10-Clutch Piston

GM Powerglide[®]

28765-05

Current 10-Clutch Parts

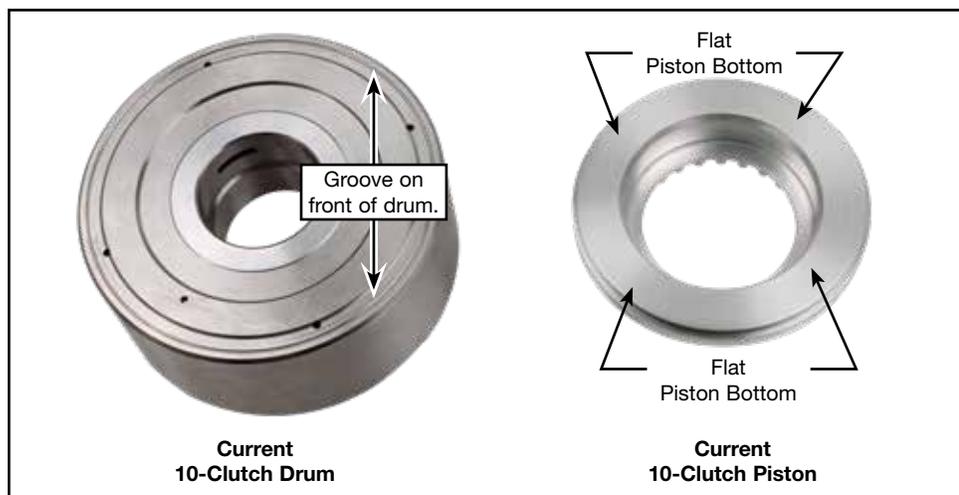
Sonnax 10-clutch piston **28765-05** is machined specifically for use with Sonnax 10-clutch drums **28756-01** and **28756-08**. These drums feature a piston bore that is .060" deeper for greater piston travel than was available from 10-clutch drums **28755-01** and **28755-08** (discontinued). These discontinued drums were specifically for use with Sonnax 10-clutch piston **28765-04** (also discontinued).

Sonnax 10-clutch pistons and drums should **ONLY** be used as matched parts. Use the images below to properly identify your parts.
